REQUEST FOR TENDER No. 22-003

Chase River Pump Station Upgrades

Addendum 4

Tender Addendum – Responses to Further Questions

PROJECT NAME CHASE RIVER FORCEMAIN NO. 1 REPLACEMENT AND PUMP STATION UPGRADES		JACOBS			
DRAWN SS	DESIGNED MP			PROJECT NO. 707564	SCALE NTS
CHECKED JG	APPROVED JG	DRAWING NUMBER CRPS-M-216	SHEET -	DATE JUNE 2021	REV 1

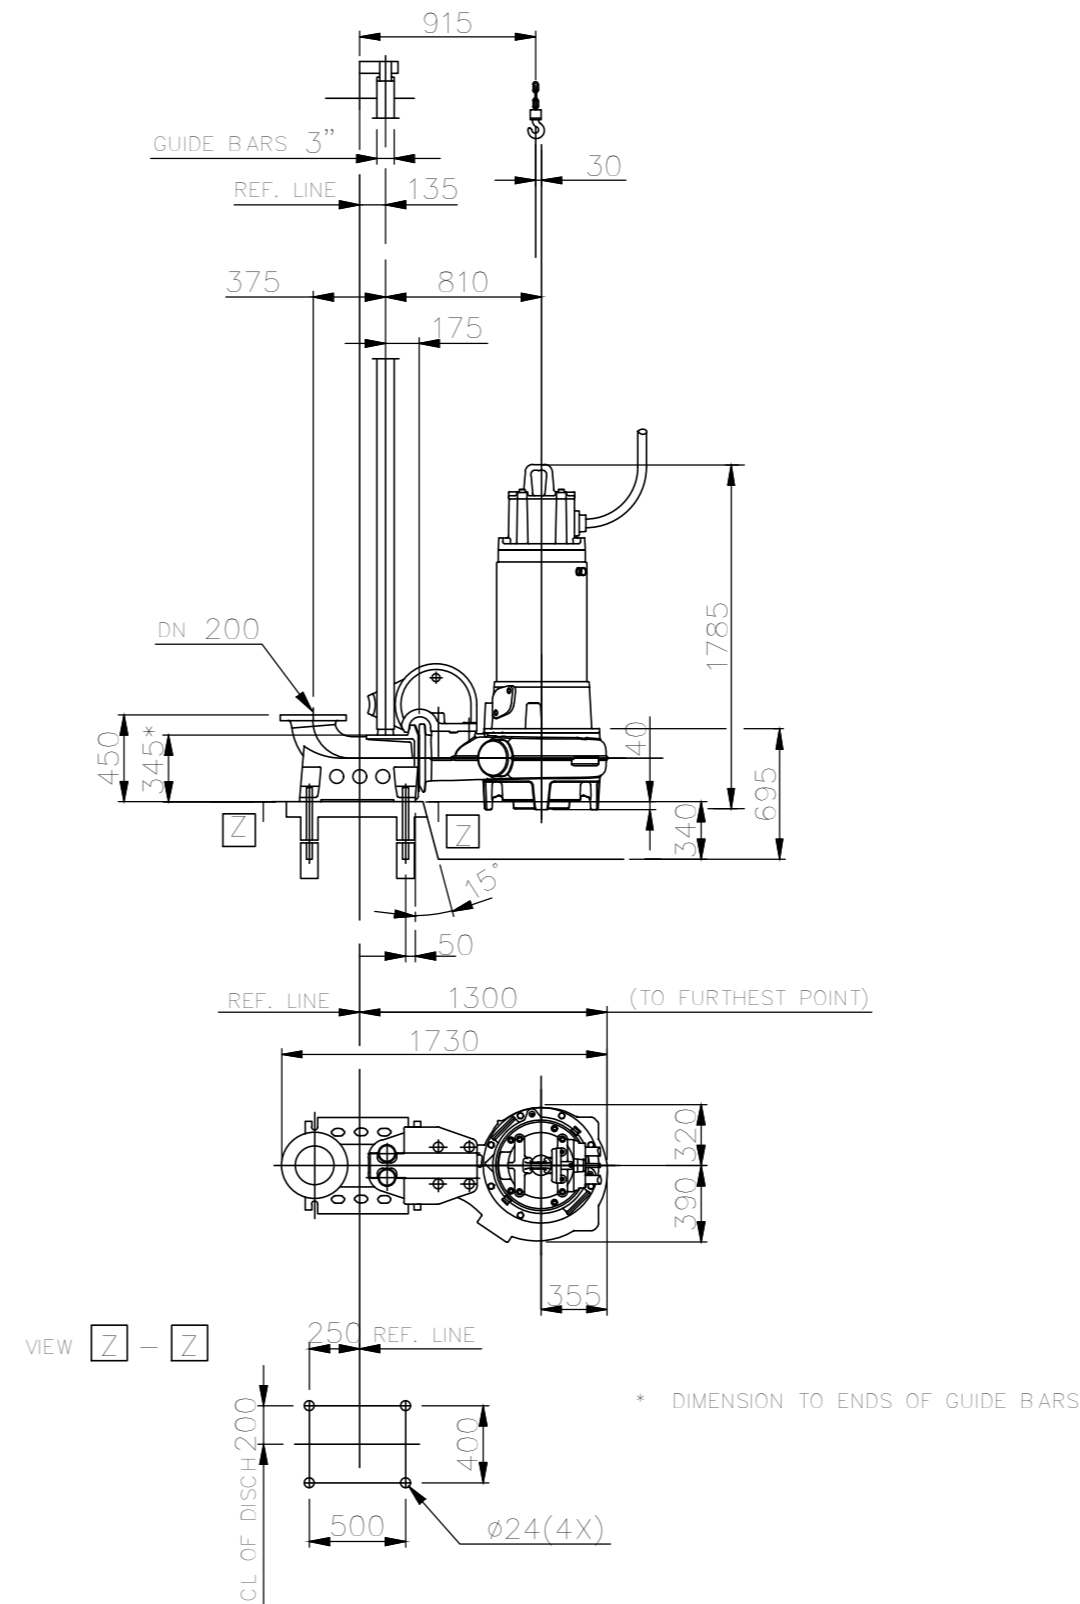
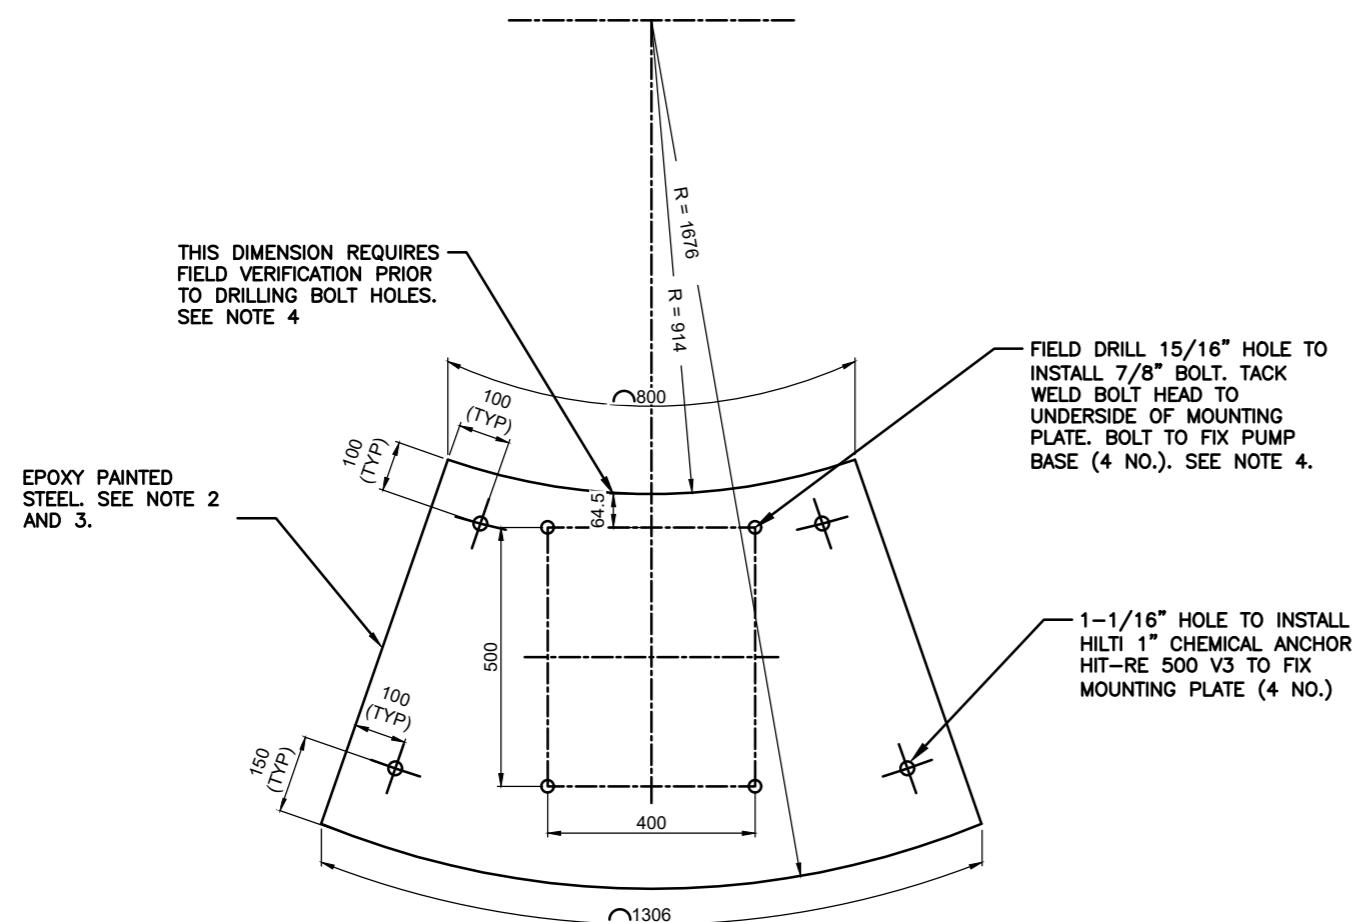
1. **Question:** Note 2 on drawing CRPS-M-216 indicates that the pump mounting plate is to be fabricated from “ASTM C1045” plate. Can you please confirm if this is correct?

Answer: The reference to “ASTM C1045” is an error. Please assume the pump mounting plate is fabricated from ASTM A36 plate instead. See corrected redline version of drawing CRPS-M-216 Rev 1 attached.

- DIMENSIONS SHOWN IN mm UNLESS NOTED OTHERWISE.
- STEEL FOR MOUNTING PLATE: ~~ASTM A1045~~ **ASTM A36**
- FOR REQUIREMENTS FOR EPOXY PAINT COATING REFER TO SPECIFICATIONS.
- FIELD VERIFY LOCATION OF EXISTING PUMP AND PUMP BASES TO POSITION BASE PLATE ON MOUNTING PLATE. VERIFY PROPOSED PUMP BASE POSITION MATCHES EXISTING LOCATION PRIOR TO DRILLING PUMP BASE HOLES.
